PLANNING UNIT REPORT
DEPARTMENT OF PLANNING AND DEVELOPMENT
August 15, 2005

**CONSIDERATION OF A REVISED PRELIMINARY/FINAL PLAT KNOWN AS
"SECOND ADDITION TO THE MEADOWLANDS" LOCATED AT 6654 MILWAUKEE
STREET:**

FINAL PLAN SECOND ADDITION TO THE MEADOWLANDS

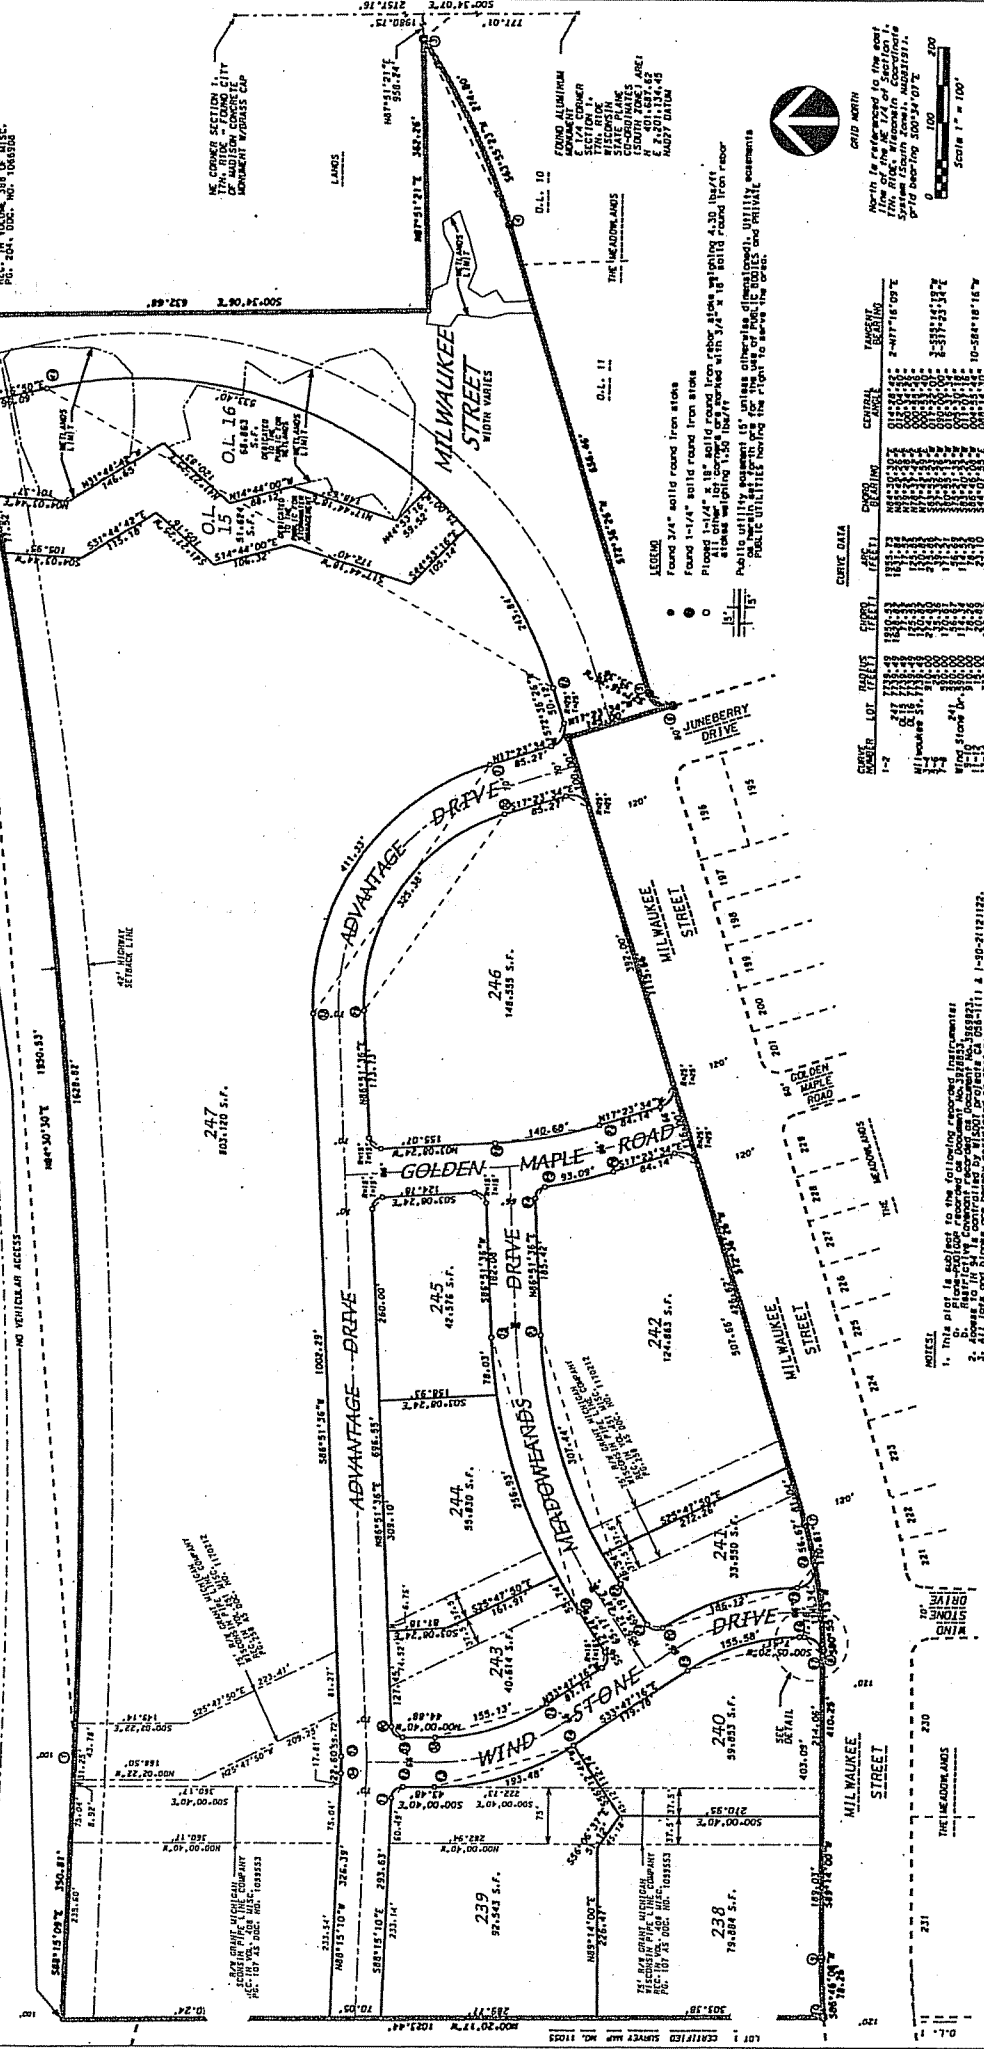
The office of the City Engineer has notified the applicant that the alignment of the easterly extension of Milwaukee Street will require modification. The right-of-way as proposed will encroach upon two small wetlands. The presence of these wetlands and the possible realignment of Milwaukee Street were identified at the time of the original preliminary plat review.

The final alignment of the easterly extension of Milwaukee Street must be resolved. The applicant will be required to furnish documentation from the Department of Natural Resources and/or Army Corps of Engineers approving the alignment of Milwaukee Street as shown on the proposed plat or negotiate a revised alignment acceptable to the City.

The Planning Unit recommends that the Plan Commission refer consideration of the revised preliminary/final plat known as "Second Addition to the Meadowlands" located at 6654 Milwaukee Street pending resolution of the Milwaukee Street alignment.

PRELIMINARY REVISED MILWAUKEE ST ALIGNMENTS

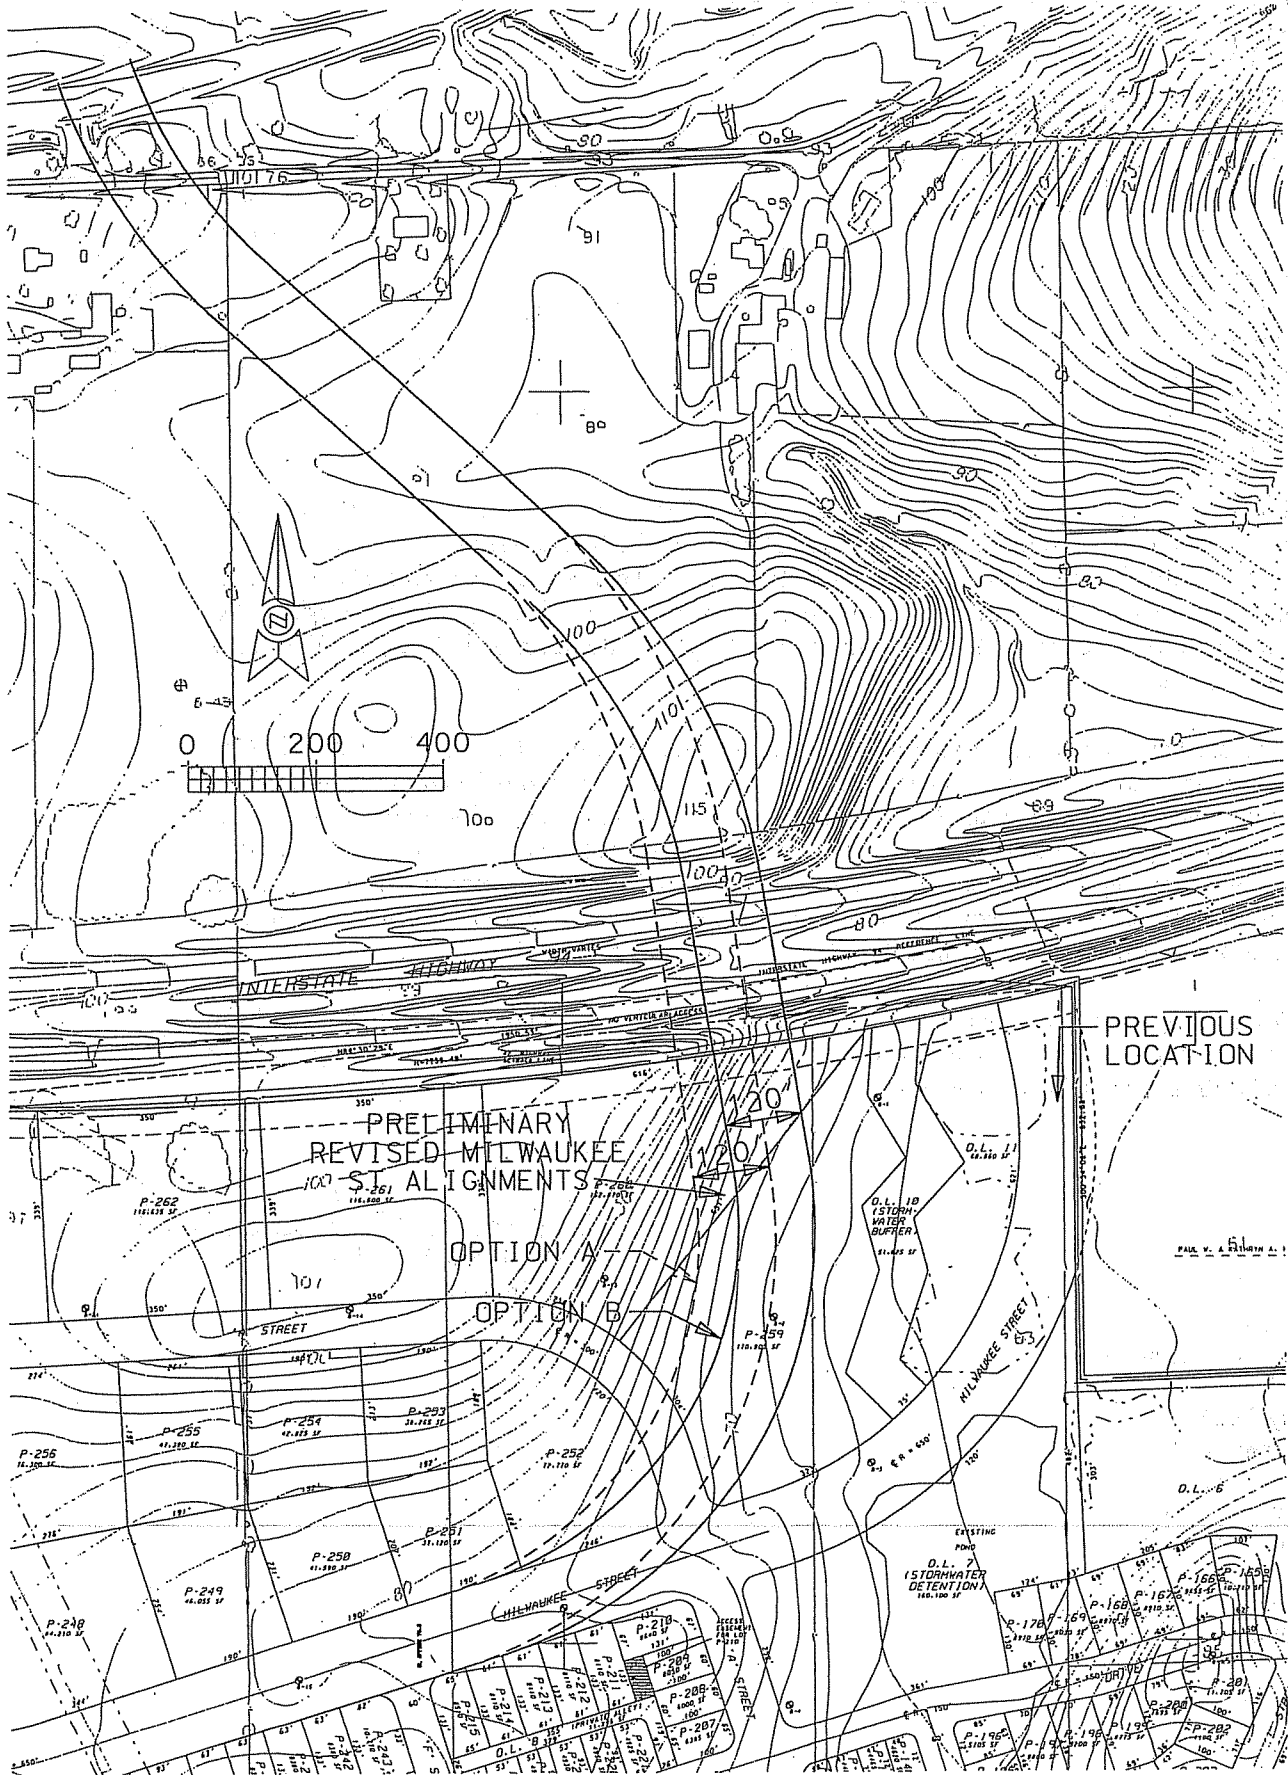
Given the unlikelihood of being able to construct Milwaukee Street through the wetlands City Engineering has drafted two preliminary alignments west of the previous location. Both of these alignments land on top of the knoll on the north side of the interstate. The intent would be to construct an overpass at this location in place of an underpass at the previous location. The State is currently reviewing the Interstate project and considering lowering the profile of the interstate. Please review the attached drawing with alignment options A and B shown. Both alignments utilize the same radii as shown on the submitted plat and maintain a 120' width.
